PERRY HILL MITIGATION PLAN

Orange County, NC
NCDEQ Contract No. 7744
DMS ID No. 100093

Subject: Comment-Response Letter
Perry Hill Mitigation Site – North Carolina Interagency Review Team Comments during 30-day Mitigation Plan Review
Neuse River Basin – CU# 03020201
Orange County, NC
Contract No. 7744

Figure 9 Monitoring Components Map
 Perry Hill Mitigation Site
 Mitigation Plan
 Neuse River Basin (03020201)

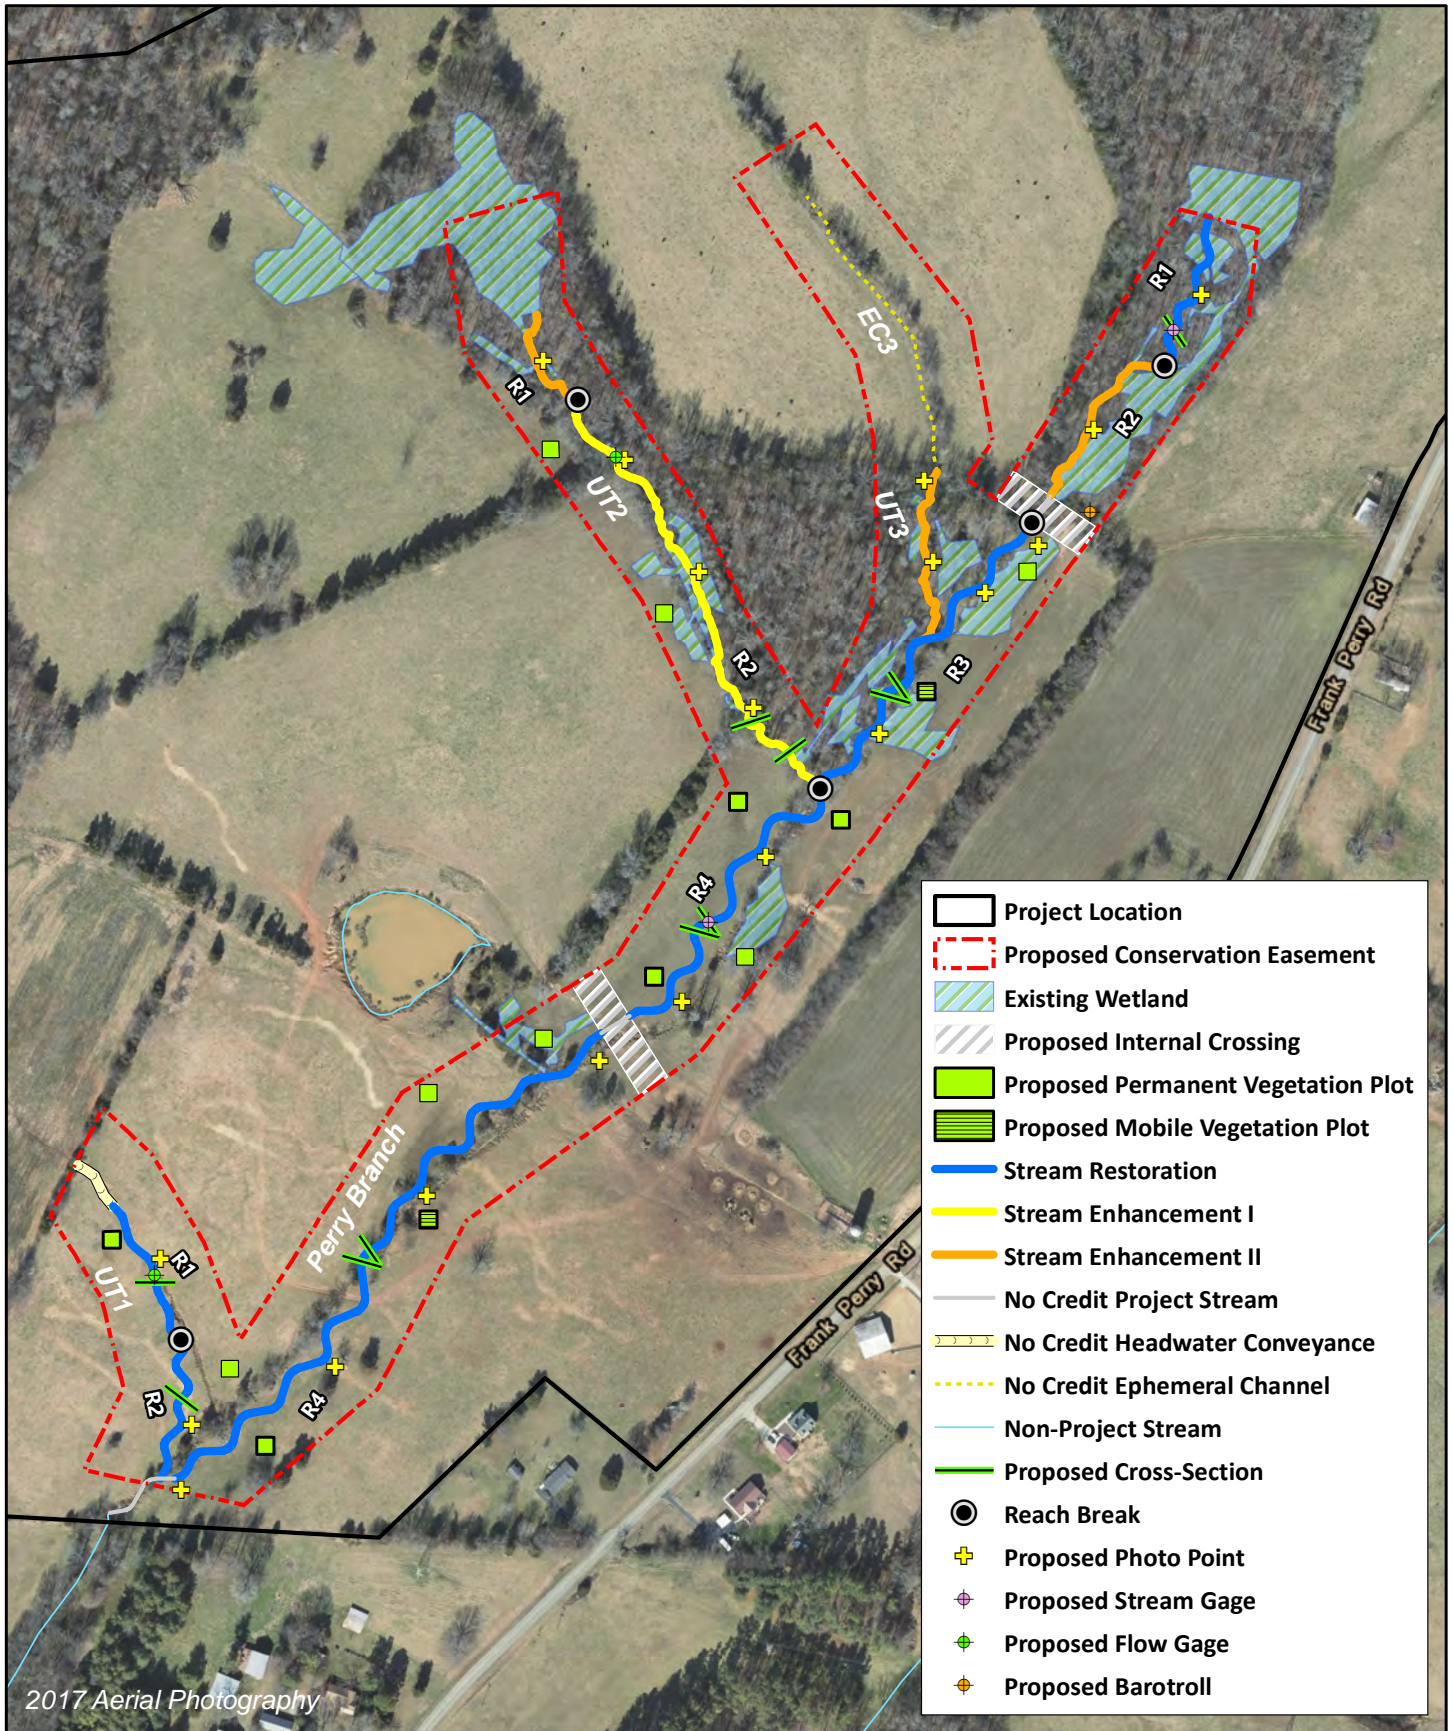
11. Figure 9 – Please show existing wetlands and label project reaches. Also, DWR requests photo points at the proposed crossings.

Response: Wildlands revised Figure 9 to illustrate existing wetlands and project reach labels. Photo points are illustrated on Figure 9.

5. Please place a veg plot in Wetland Q.

6. Please include photo points at crossings.

Response: Wildlands revised Figure 9 to illustrate a vegetation plot in Wetland Q.

Response: Wildlands revised Figure 9 to illustrate photo points near the crossings.

Figure 2 Site Map
 Perry Hill Mitigation Site
 Riparian Buffer Mitigation Plan
 Neuse River Basin (03020201)

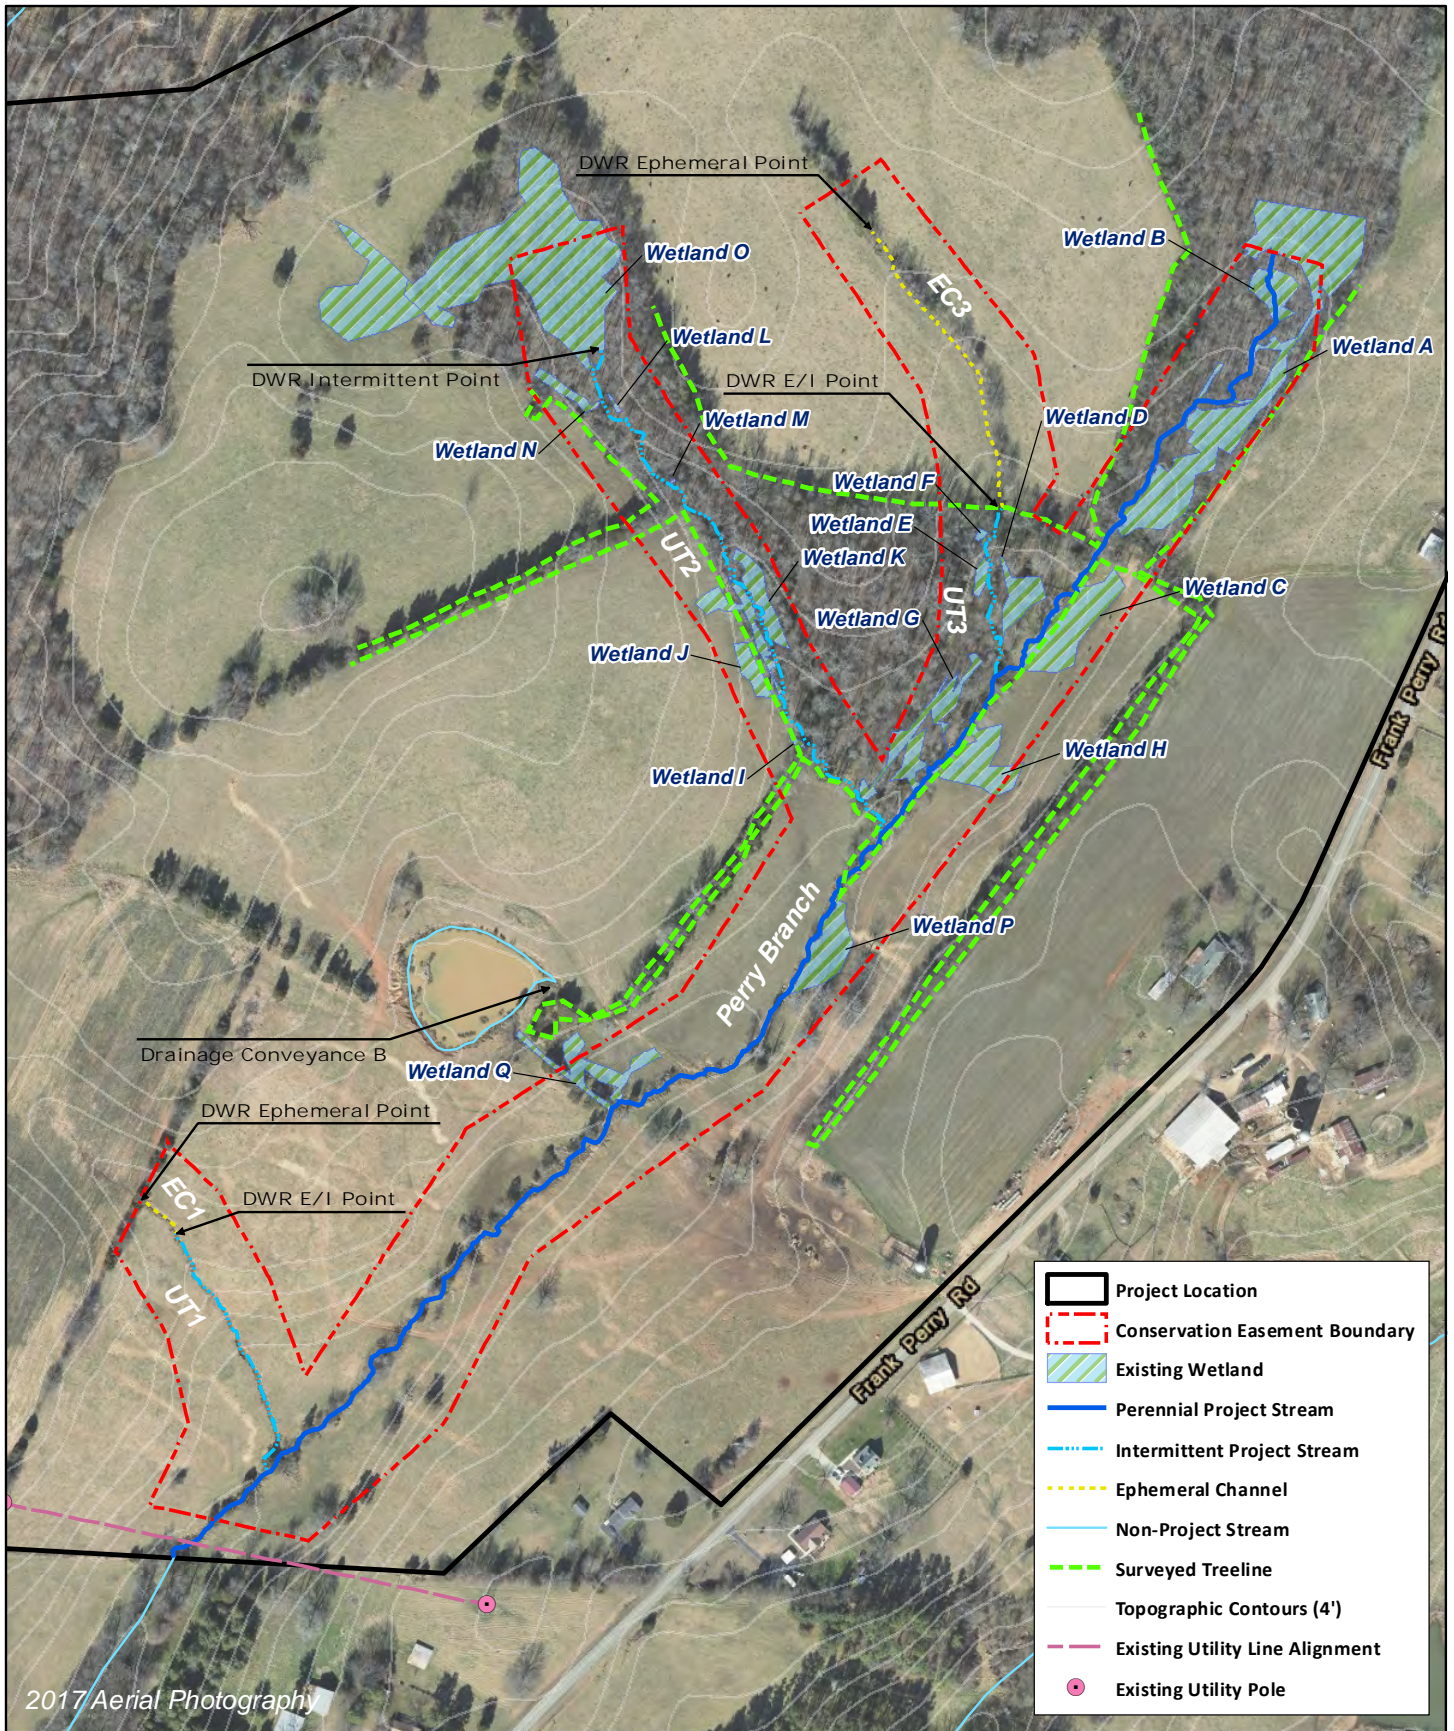
18. **Figure 2** – Call out start of ephemeral streams as “DWR Ephemeral Point.” Call out intermittent stream start location “DWR Intermittent Point.” Label Drainage Conveyance B. Call out start of intermittent stream on UT1 as “DWR E/I Point.”

Response: Wildlands revised Figure 2.
19. **Figure 6** – Show the proposed easement boundary for the Perry Hill Mitigation Bank.
Response: Wildlands revised Figure 6 to illustrate the bank boundary.
